NUCLEAR PACKAGING, INC.

71-9145

REFERENCE: DOcket No. 71-9145
Certificate of Compliance No. USA/9145/A

INSTRUCTIONS FOR INCORPORATION OF REVISION 2
AMENDMENTS TO NUPAC 50 SERIES CASK APPLICATION
DATED AUGUST, 1982

Tie-down Method

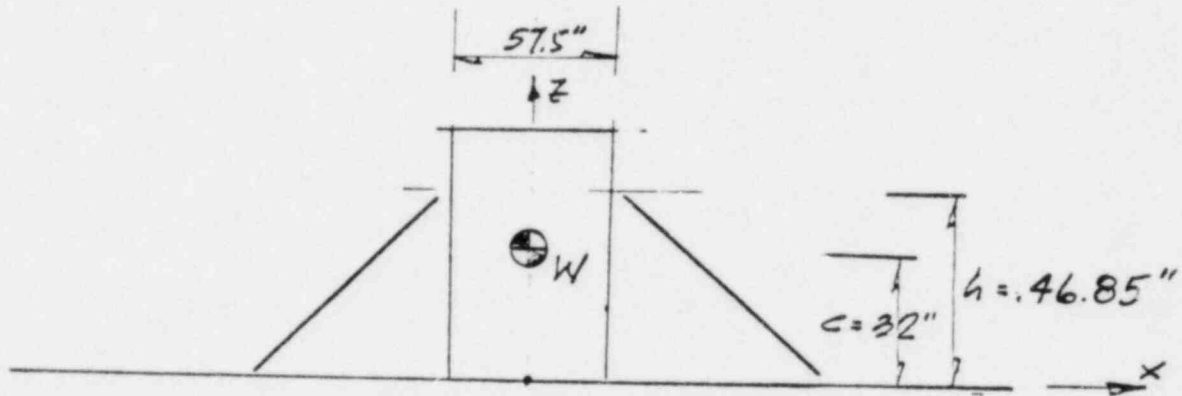
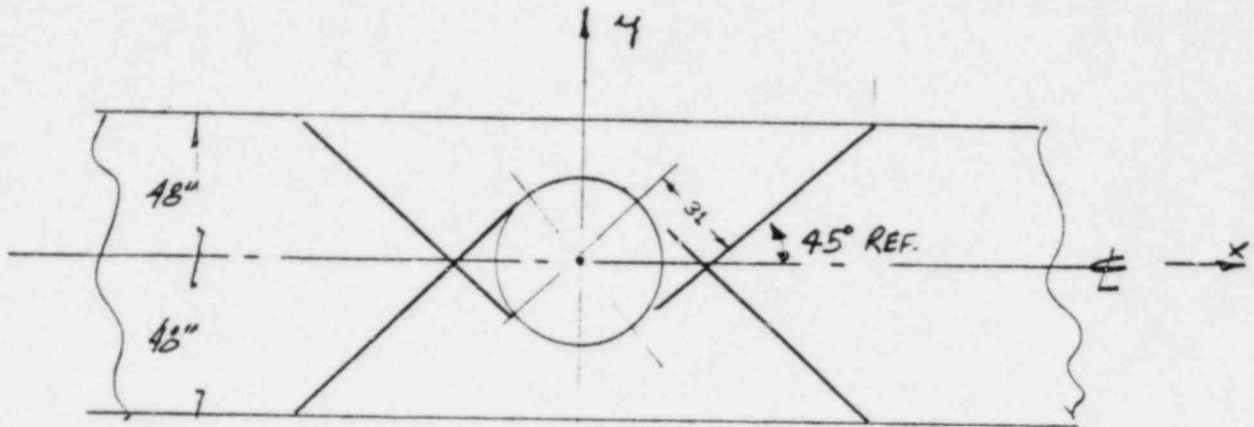
Each of the four tiedown lugs is located at 90° with respect to the package at an elevation above the package base which ranges from 41.35 inches to 46.85 inches, depending upon version. The NuPac 50-4.0L version is the heaviest and has its c.g. at maximum elevation above the base; consequently is most critical. The tiedown scheme for the NuPac 50-xxL assumes a modified basket hitch arrangement involving crossed cables tangent to the package body at the tiedown lug with an approximate 2:1 horizontal to vertical aspect ratio. Tiedown cables are assumed to be tied to the transporter four feet each side of the transporter centerline. The geometry of the tiedown scheme used for loads evaluation is illustrated in the following sketch.

The tiedown cable geometry may be summarized as:

<u>Direction</u>	<u>Length</u>	<u>Direction Cosine</u>
Longitudinal	$l_x = 67.98$	$B_x = .635647$
Lateral	$l_y = 67.98$	$B_y = .635647$
Vertical	$l_z = 46.85$	$B_z = .438071$

X-20-201D

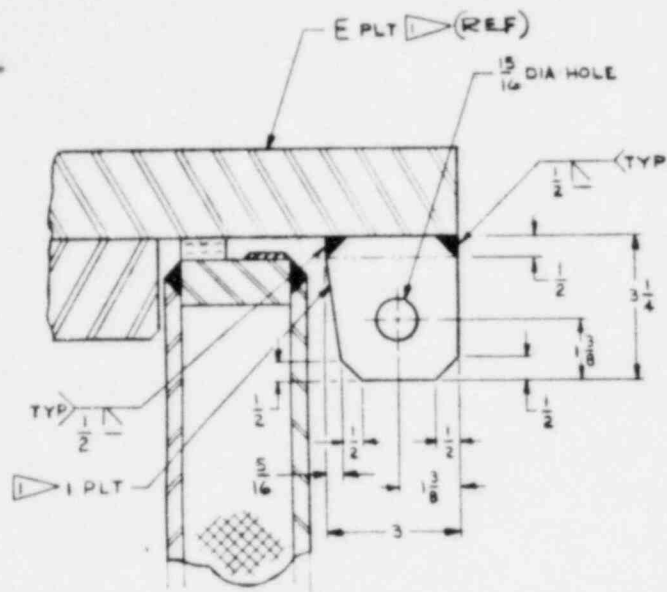
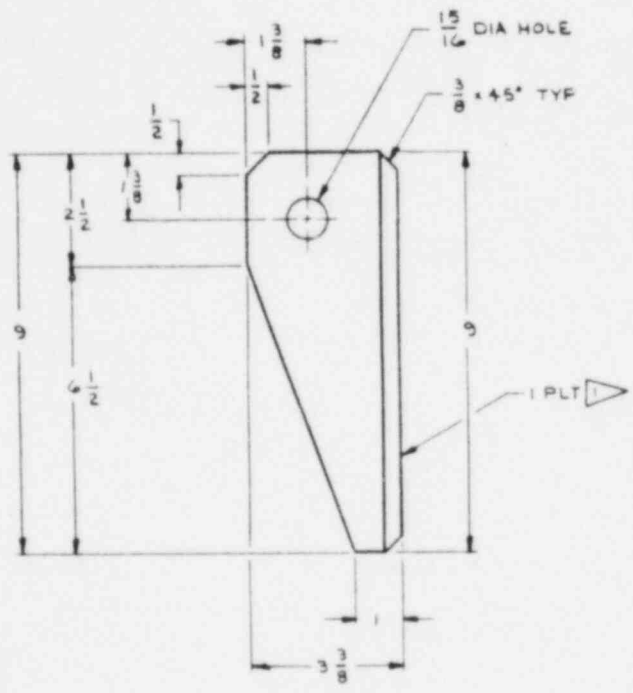
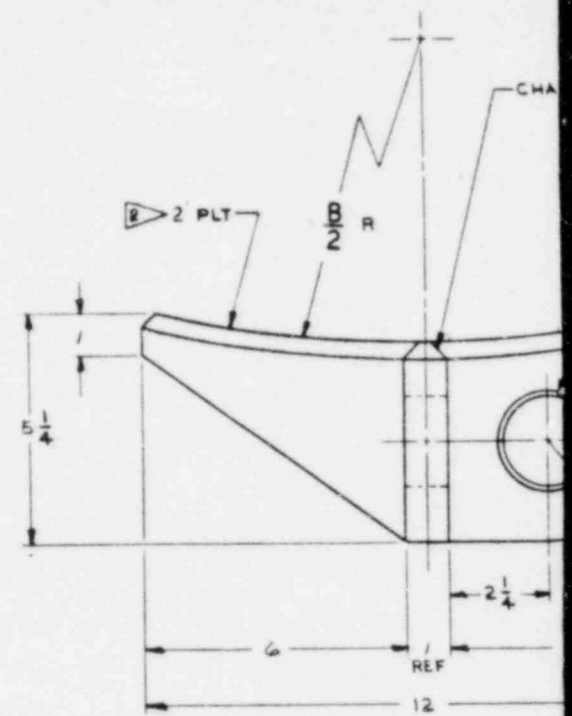
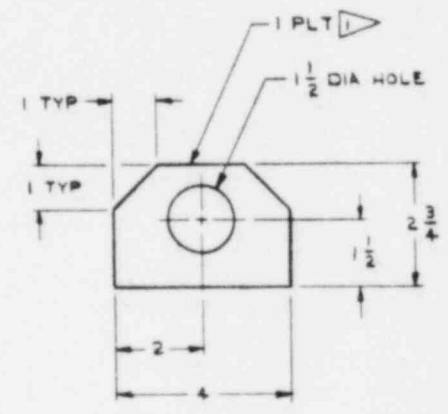
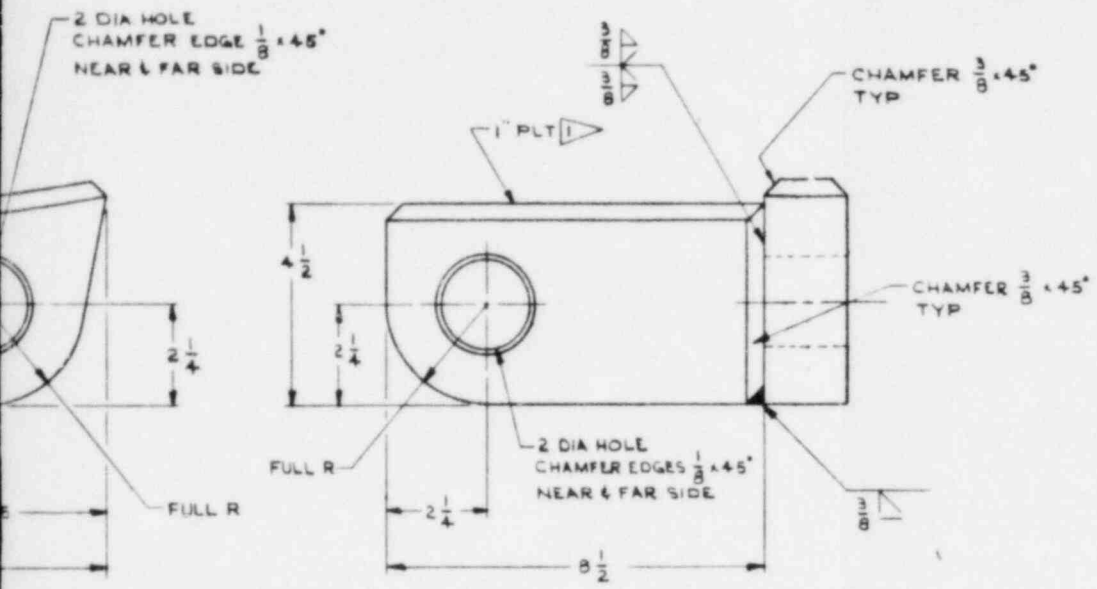
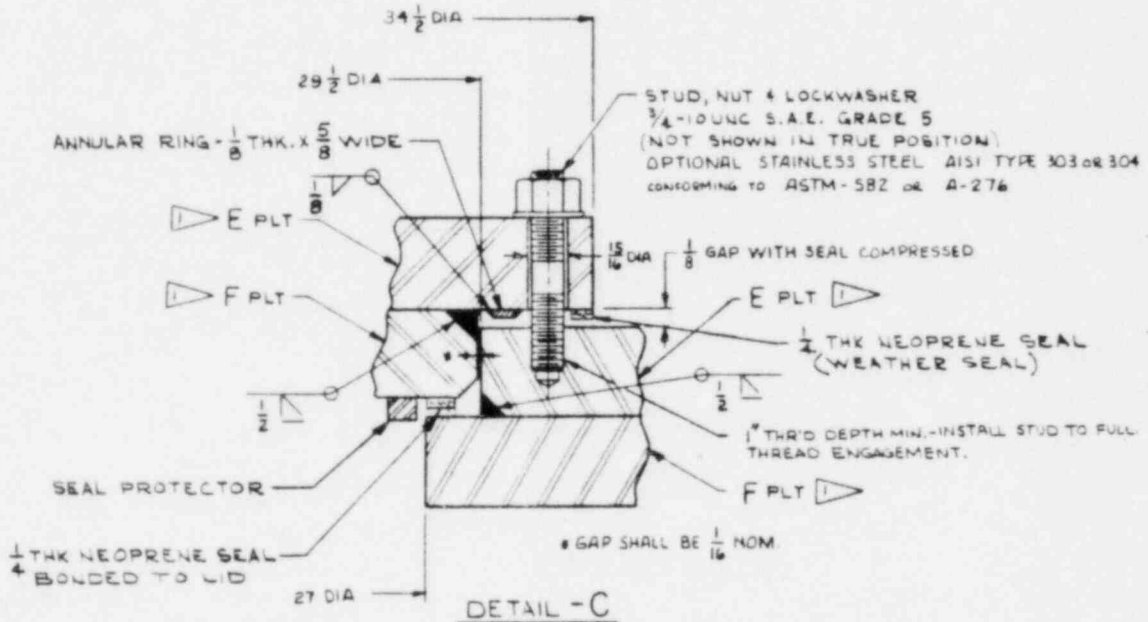
The enclosed revisions change the dimensioning system used in the SAR drawing to reflect a constant position of the tiedown/lifting lugs relative to the top of the cask. Corresponding changes to the applicable sections of the Safety Analysis Report result in small changes in margins of safety. In all cases, positive margins of safety are retained.

REVISIONS				
ZONE	LTR	DESCRIPTION	DATE	APPROVED
B		REVISED DWG TO CORRECT DRAFTING ERROR LID WAS SHOWN 5/16 IN. INSTEAD OF 1/8 IN.	12/79	[Signature]
C		REVISED DWG TO CHANGE LIFT/TIE DOWN LIFT LOCATION DIMENSION WAS SHOWN 55/16 FROM BASE	8/25/82	[Signature]
